UNITED STATES PATENT AND TRADEMARK OFFICE

APPLICATION NO.	FILING DATE	FIRST NAMED INVENTOR	ATTORNEY DOCKET NO.	CONFIRMATION NO.
10/757,629	01/14/2004	Mark James Kline	8194C	4664

Office Action Summary

DETAILED ACTION

FIG. 1

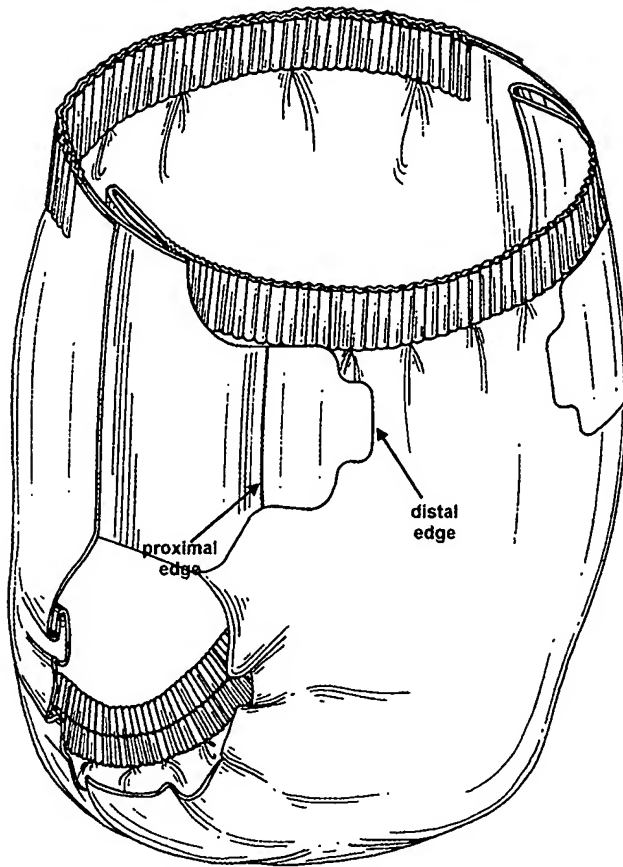
5. Claims 1, 4-5 and 8-10 are rejected under 35 U.S.C. 103(a) as being unpatentable over Schmidt (US 3,797,495 herein 'Schmidt'), and further in view of Vukos et al. (US Des. 422,078 herein 'Vukos'). Regarding claims 1 and 8-9 Schmidt discloses a diaper 20 with absorbent pad/chassis 22 to be worn about a wearer (col. 6, ll. 39-43, figure 2) comprising: a surface fastening system 28 with first tape base/fastening element 12 and protective cover strip/second facing fastening element 30, the surface fastening system 28 including an effective Y dimension substantially parallel to the longitudinal article axis (col. 6, ll. 63-68, figure 3), wherein the backing tape used in surface fastening system 28 is able to withstand different tear and tensile forces applied across the tape in varying directions and degrees when user moves (col. 2, ll. 1-11). Schmidt *does not expressly disclose* the Y dimension increasing from a distal to proximal edge of the first fastening system. **Vukos** discloses disposable absorbent article to be worn about a user with a Y dimension increasing from a distal to proximal edge (figure 1).

Regarding claim 4 Vukos further discloses the proximal/lower edge being longer than the distal/upper edge (figure 1).

Regarding claim 10 Vukos further discloses the disposable absorbent article with first and second fastening elements attached to form a waist opening and a pair of leg openings (figures 1 and 4).

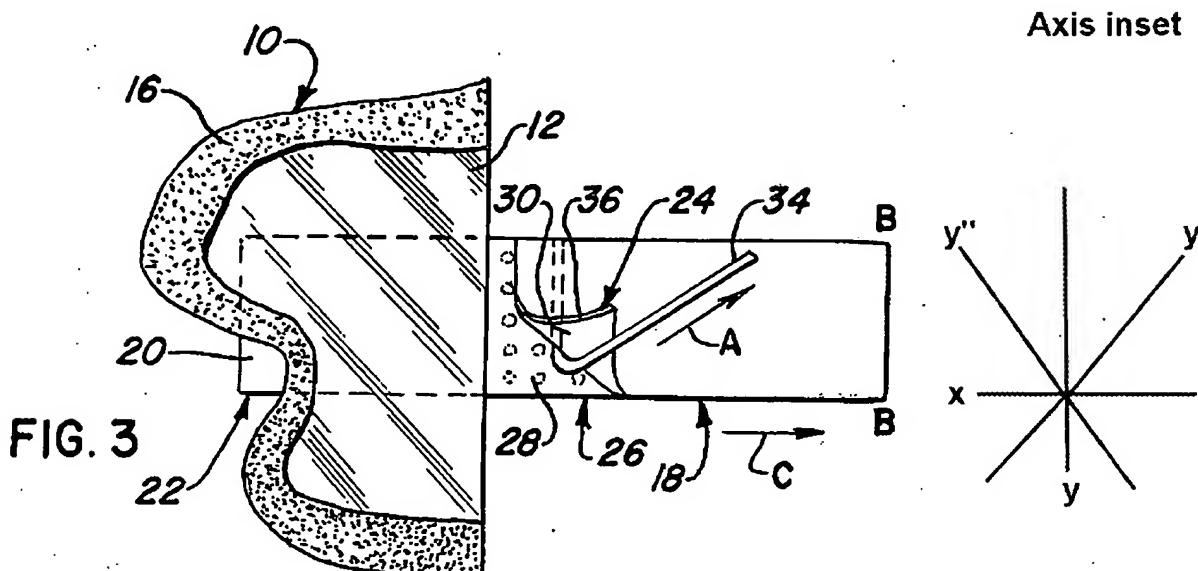
One would be motivated to modify the fastening system of Schmidt with the increasing Y-dimension of Vukos since doing so would provide an easier mechanism to grip and open the tab and since both references disclose wearing articles with fastening systems. Therefore, it would be obvious to one of ordinary skill in the art at the time the invention was made to modify the fastening system, thus providing a fastening system with an increasing Y-dimension from the distal to proximal edge.

Regarding claim 5 Schmidt/Vukos further disclose protective cover strip/second facing fastening element 30 having a portion of the lower edge being unjoined or at least partially detached from the underlying structure (figure 3).
